Thursday, September 5, 2019
PERMIT MODIFICATION APPROVAL
Horizontal 6A / New Drill

Re: Permit Modification Approval for DOC 9
47-095-02626-00-00

Modify Casing Sizes on Conductor and Surface Casing

RE: Doc 9 Modification

CASING AND TUBING PROGRAM

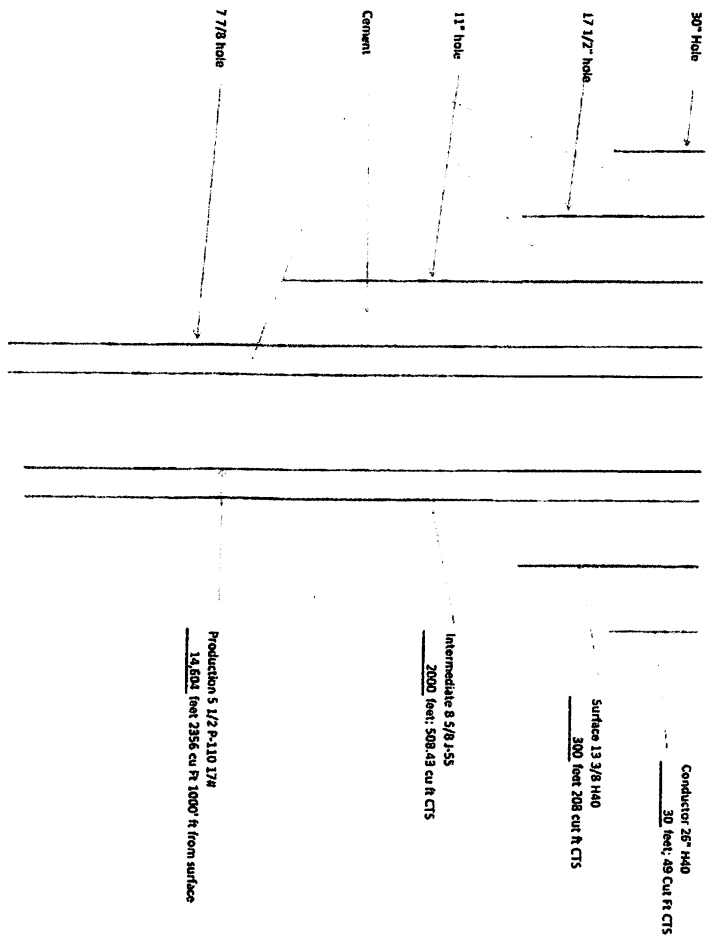
Please find Jay Bee Oil and Gas, Inc's modification to the Doc 9 well permit. The modification includes a change in size of the Conductor and Freshwater casings.

TYPE	Size (in)	New or Used	Grade	Weight per ft. (lb/ft)	FOOTAGE: For Drilling (ft)	INTERVALS: Left in Well (ft)	CEMENT: Fill-up (Cu. Ft.)/CTS
Conductor	26	New	H40	202	30'	30'	49 Cut Ft CTS
Fresh Water	13 3/8	New	H40	48	300'	300'	208 Cu Ft. CTS
Coal							
Intermediate	8 5/8	New	J55	24	2,000'	2,000'	508.43 CTS
Production	5 1/2	New	P110	17	14,604'	14,604'	2356 CF1000' from surface
Tubing	N/A						
Liners	N/A

TYPE	Size (in)	Wellbore Diameter (in)	Wall Thickness (in)	Burst Pressure (psi)	Anticipated Max. Internal Pressure (psi)	Cement Type	Cement Yield (cu. ft./k)
Conductor	26	30	.375	n/a	50	Class A	1.19
Fresh Water	13 3/8	17 1/2	.330	1,700#	1,000	Class A	1.26
Coal							
Intermediate	8 5/8	11	.264	2,950#	1,500	Class A	1.45
Production	5 1/2	7 7/8	.304	15,000#	2,500	Type 1 Cement	1.34
Tubing	N/A						
Liners	N/A
